RE: WINR-Center, Woodbine Site
Proposed Compost Facility
Harrison County, Iowa
ProAg Project No. 21-055

Please accept our reply to your comments dated January 16, 2026, on the WINR-Center organic compost facility.

Engineering Review

Routing Diagram for Runoff Basin design

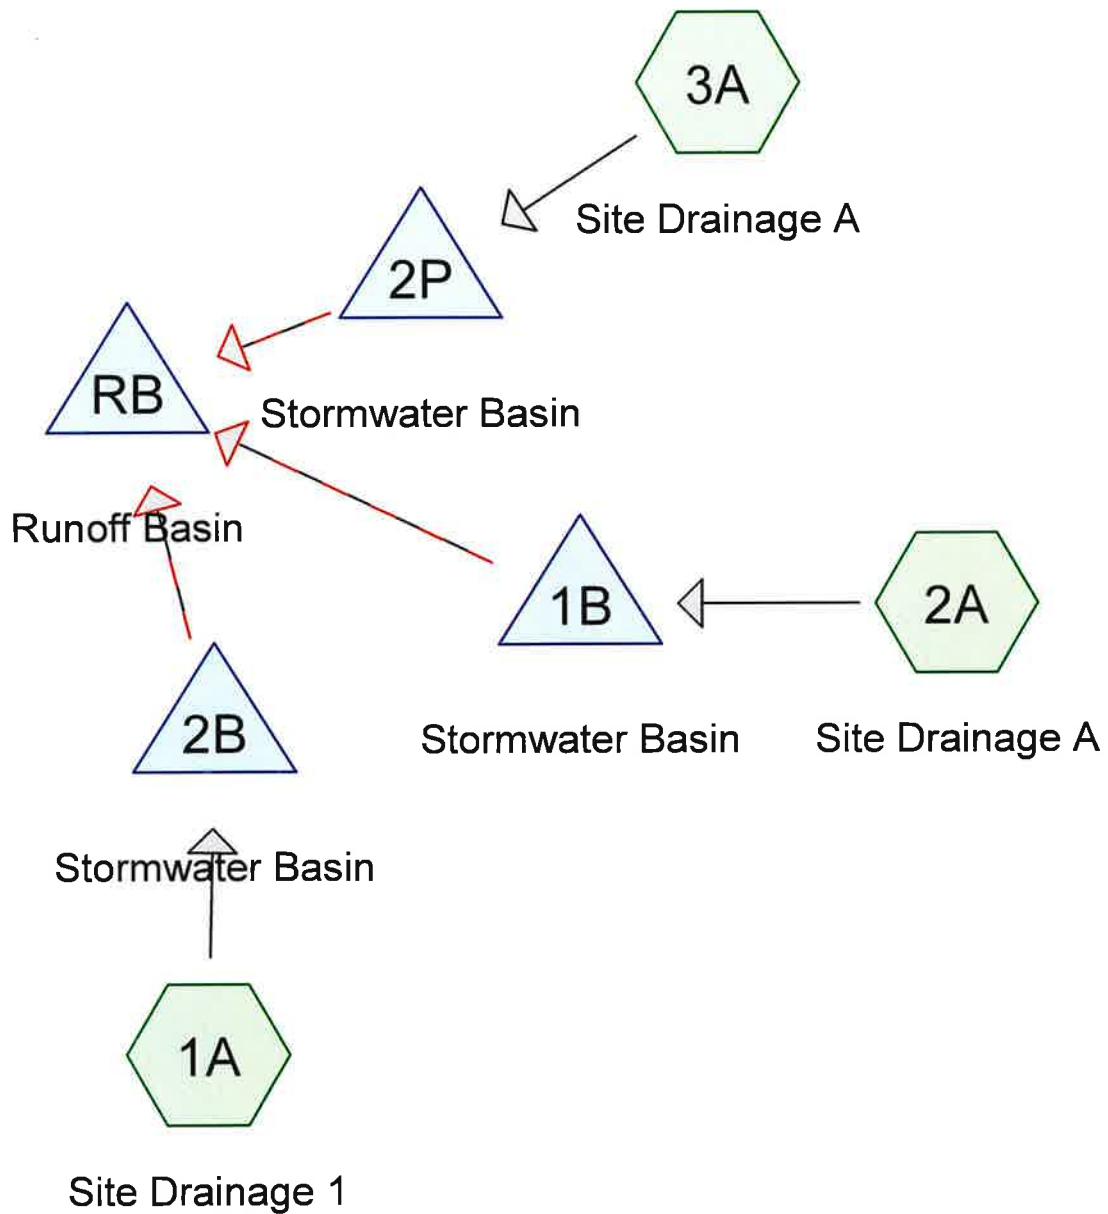
- **Stormwater Calculations**

See attached HydroCAD calculations. The stormwater conveyance system is designed to route the 25-yr, 24-hour storm through the perforated riser intakes and convey the 100-yr storm through auxiliary spillways so that all runoff is collected in the runoff basin. The site will not discharge.

COMPOSTING BUILDING
CROSS SECTION
(NOT TO SCALE)

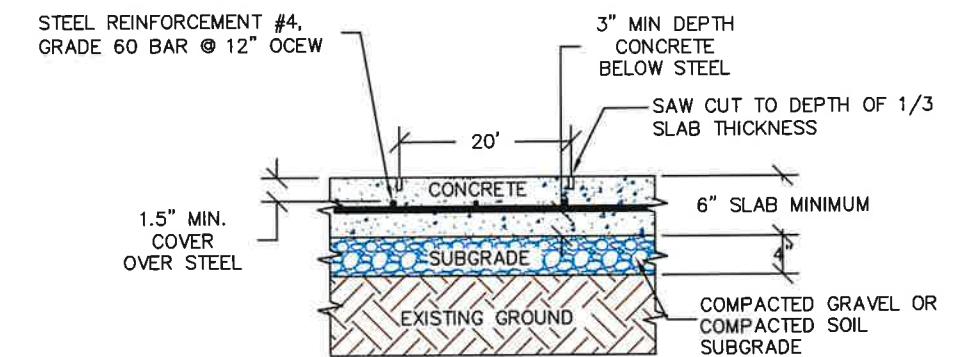
- **Hoop Building Design**

The hoop structures will serve as covers for the static piles. The trusses will be mounted to precast concrete, typical of the temporary structure design for fabric covered "hoop" structures. A typical detail has been added, but no vendor has been selected at this time. When selected, the structure will be specified to meet the Iowa state building code, Risk Category I, with wind and snow loads for Harrison County. See updated engineering drawings.

PIT/RAMP LAYOUT

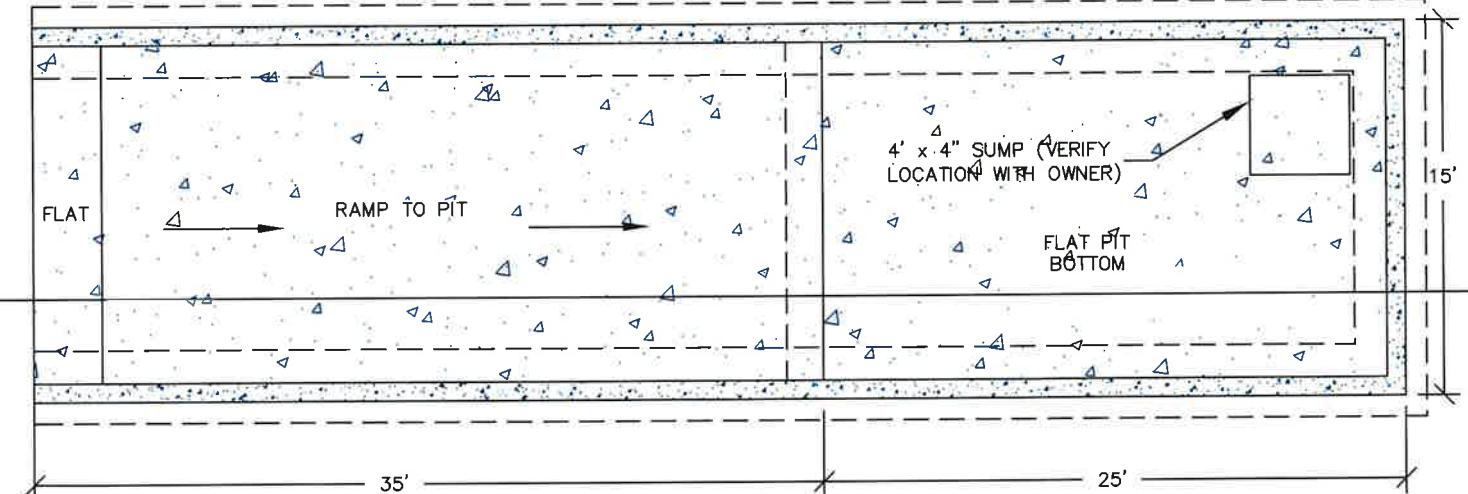
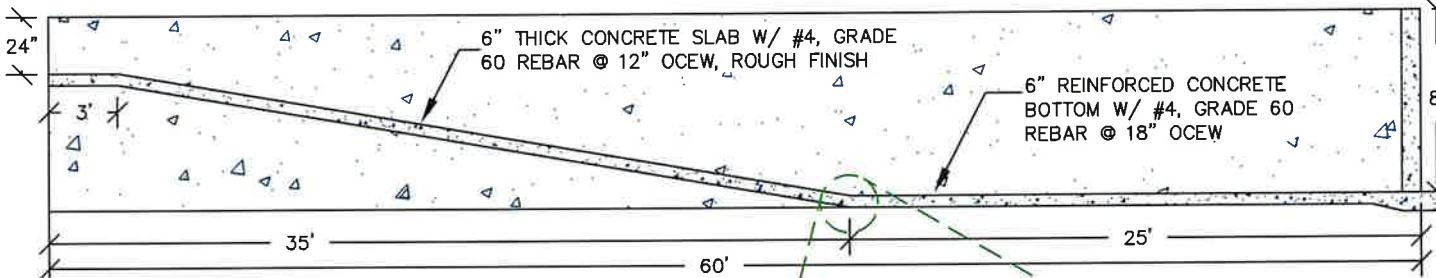
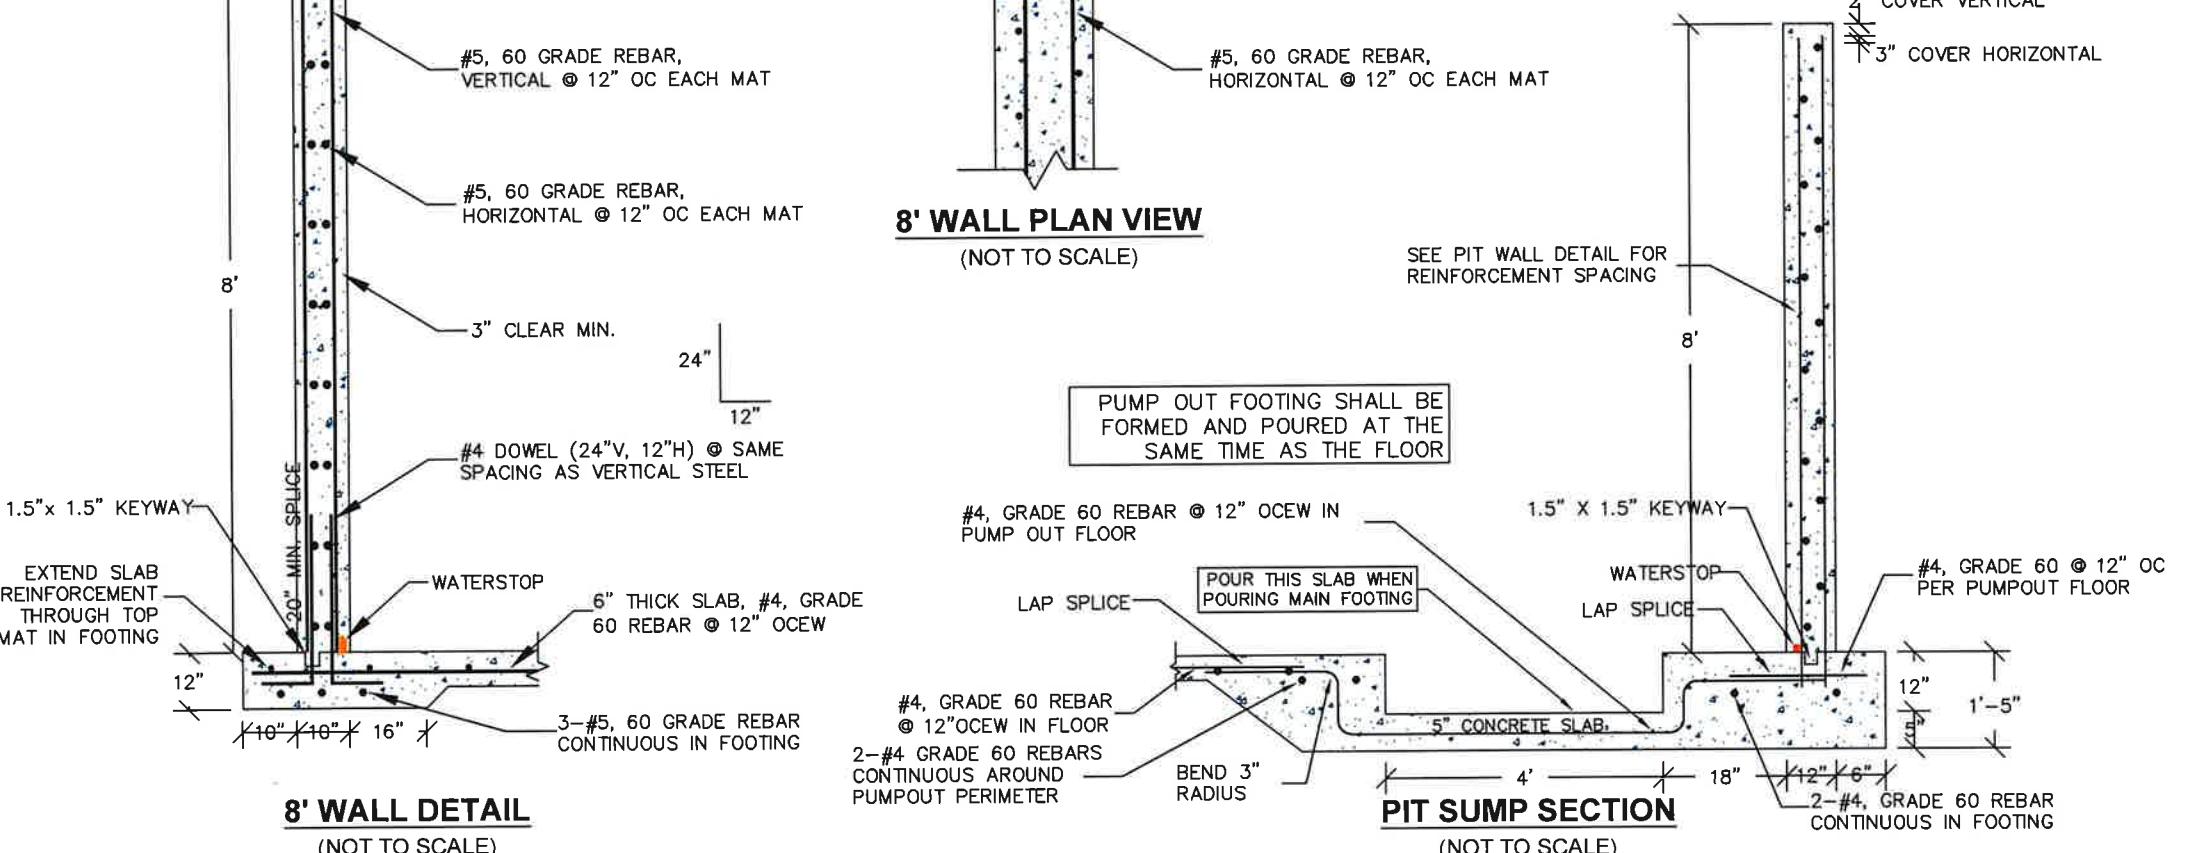
- **Liquids Pit**

No liquid feedstocks are proposed with this application. However, a watertight reception pit is now included in the design details. See revised construction drawings.
